ADDENDUM NO: 1

PROJECT: Roof Replacements for Noblesville East Middle School and Hinkle Creek Elementary School

PROJECT NO: 2025085

DATE: 03/31/2026

10 TYPICAL ROOF LADDER SECTION

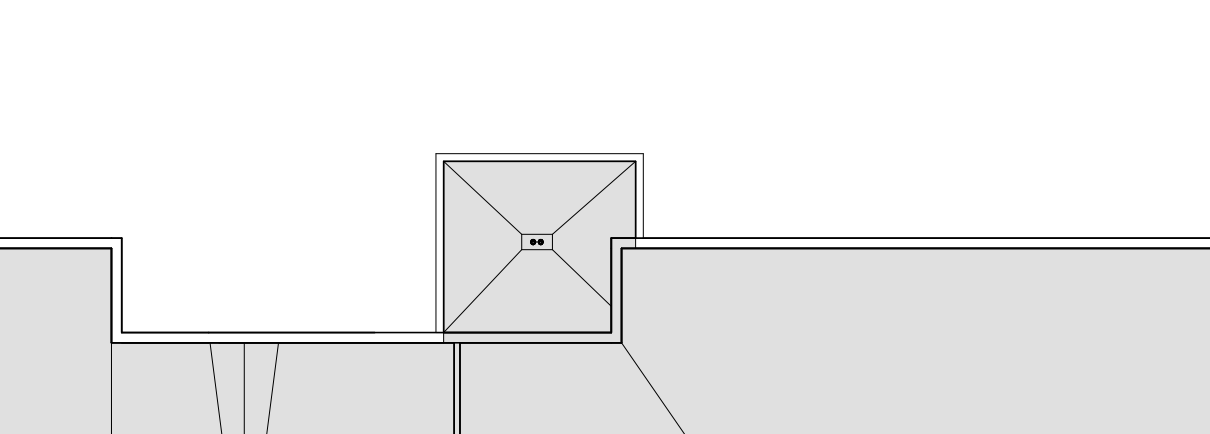
- A. Roof Plan Notes
 - 1. Spec section ~~07-53-23~~ revised to read **07 54 19** for notes #1, 2, 3, 4, 9 and 14.
- B. Details 2/A201, 3/A201, 4/A201, 5/A201, 6/A201, 8/A201, 9/A201, 10/A201
 - 1. References to Spec Section ~~07-53-23~~ revised to read **07 54 19**, typical.
 - 2. References to Spec Section ~~06-10-00~~ revised to read **06 10 53**, typical.
- C. Detail 8/A201
 - 1. Reference to Spec Section ~~07-72-00~~ revised to read **07 71 00**.
- D. Detail 3/A201
 - 1. Detail revised to show existing ballast roof removed and replaced with new PVC membrane roofing system, typical.
- E. Overall Roof Plan
 - 1. Additional instances of Note #10 added to drawings as shown.

4 ROOF DETAIL
SCALE: 1 1/2" = 1'-0"

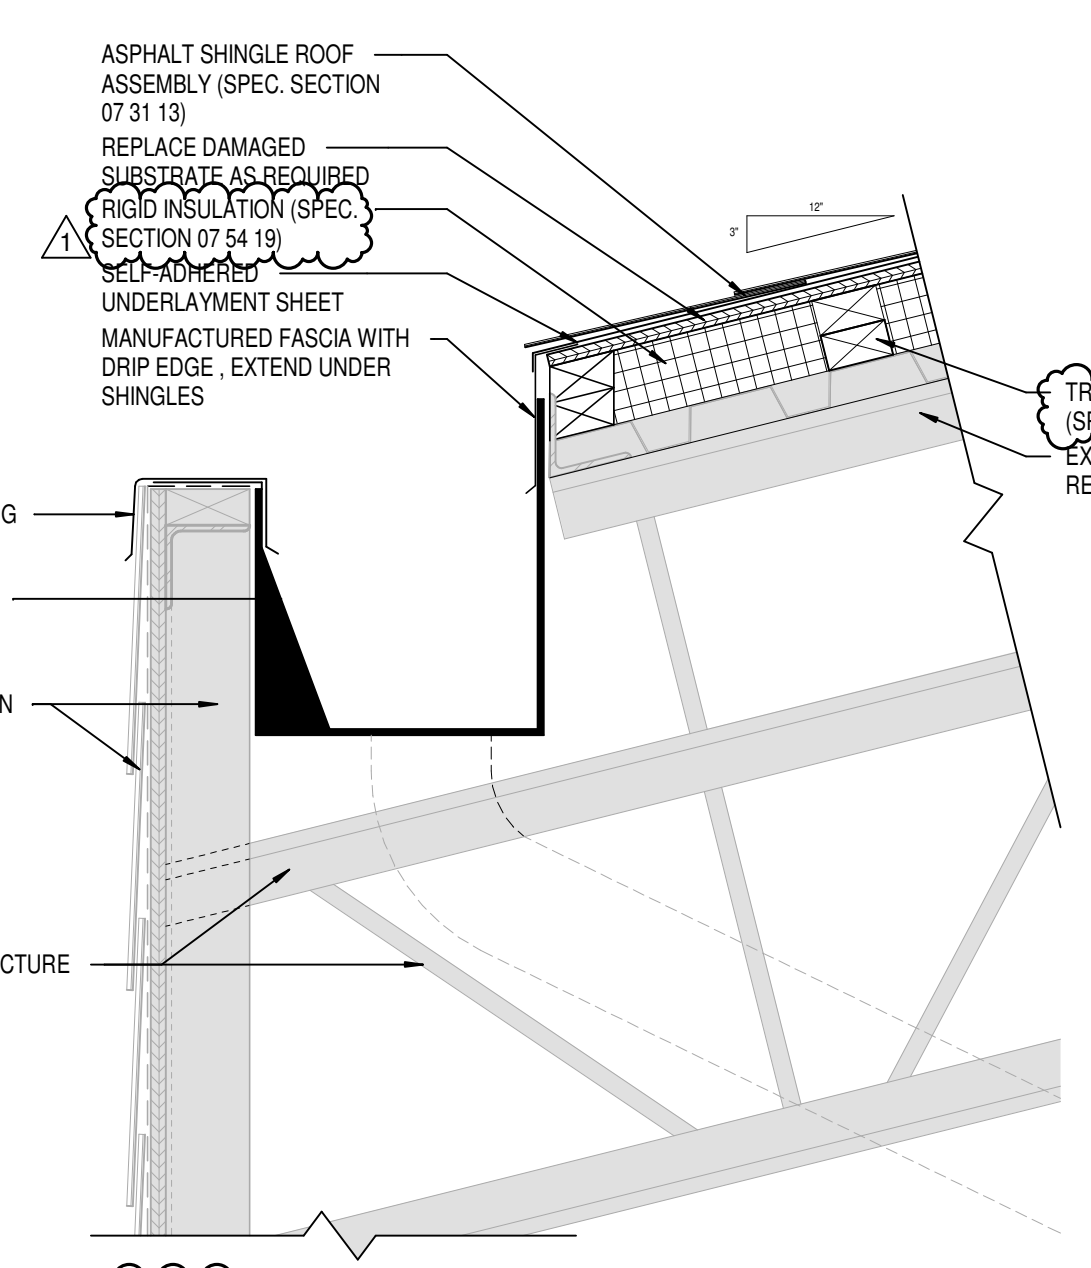
- A. Details ~~5/A201~~ and ~~6/A201~~ renumbered to be **2/A201** and **3/A201**, respectively.
- B. Spec section ~~07-53-23~~ revised to read **07 54 19**, typical.
- C. Spec section ~~06-10-00~~ revised to read **06 10 53**, typical.
- D. Roof slopes indicated at asphalt shingle roof surfaces as shown.
- E. Roof detail 4/A202 added to sheet and section callouts added to plan as shown.
- F. Roof note #5 revised to read, "FIELD FABRICATED EXPANSION JOINT PER MANUFACTURER'S STANDARD DETAILS. CONTINUE EXPANSION JOINT UP AND OVER PARAPET AND CONNECT OT EXISTING EXPANSION JOINT ON PVC ROOF. REFER TO DETAIL 4/A202 FOR MORE INFORMATION."

1 OVERALL ROOF PLAN
SCALE: 1" = 25'-0"

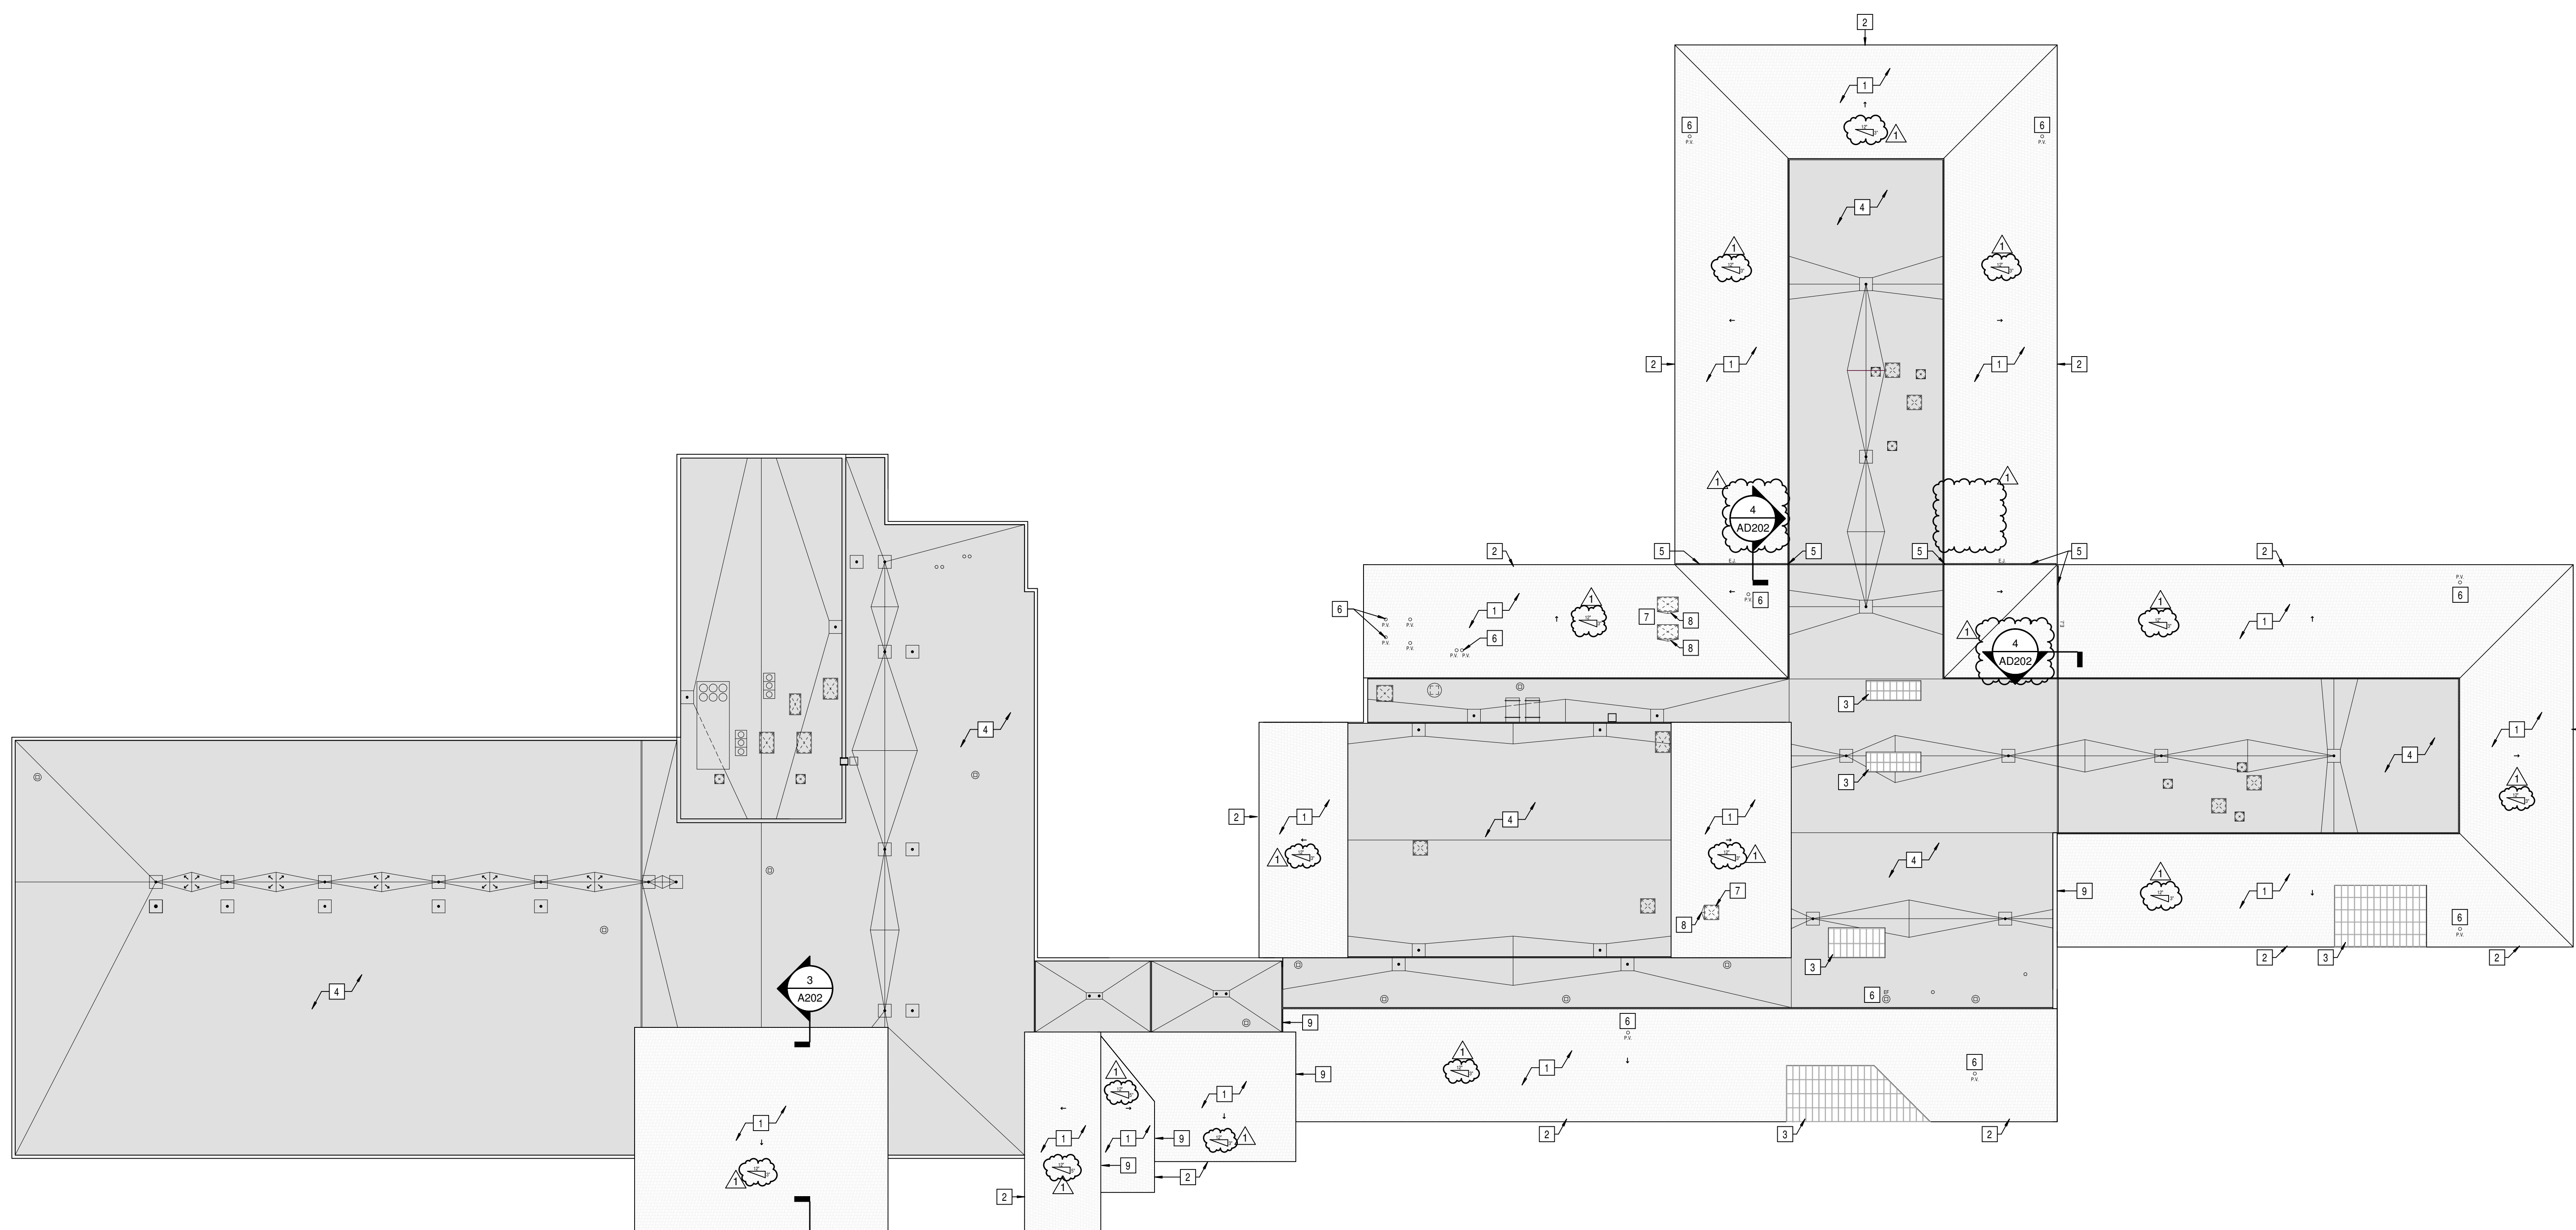
- A. Slopes vary from one asphalt shingle roof surface to the next and are assumed based on observations and limited information available from existing drawings. A202 has been revised to show slope values with 3"/12" assumed as the minimum unless otherwise noted. Contractors to verify in field the slopes of each roof surface, typical.
